LTR-NRC-21-6

Subject: Fuel Criterion Evaluation Process (FCEP) Notification of the 15x15 Advanced Debris Filter Bottom Nozzle (ADFBN) Design (Proprietary/Non-Proprietary)

**Fuel Criterion Evaluation Process (FCEP) Notification of the 15x15 Advanced Debris Filter
Bottom Nozzle (ADFBN) Design**

Figure 1: Westinghouse 15x15 modified Debris Filter Bottom Nozzle

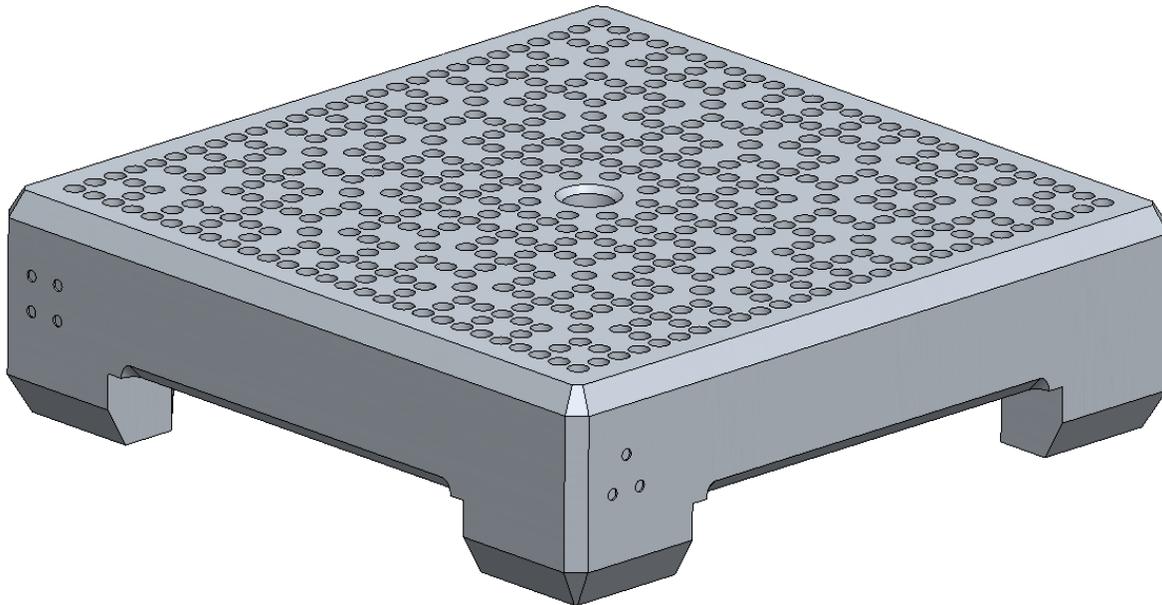
As shown in Figure 1, there is a gap between the bottom of the side skirts and the lower core plate that the mDFBN sits on which is a potential path for debris to travel around the bottom nozzle. Specifically, debris in the coolant flow under the bottom nozzle can pass under the side skirts and into the gaps between adjacent fuel assemblies where it can then travel into the fuel bundle region potentially leading to debris-induced fretting failures. Westinghouse closely tracks fuel failures and the current fuel design with the mDFBN bottom nozzle have excellent performance with respect to minimizing debris-induced fretting failures. However, recent indications are that debris may be bypassing the mDFBN, passing through the gaps between mDFBNs and then into the fuel bundle region.
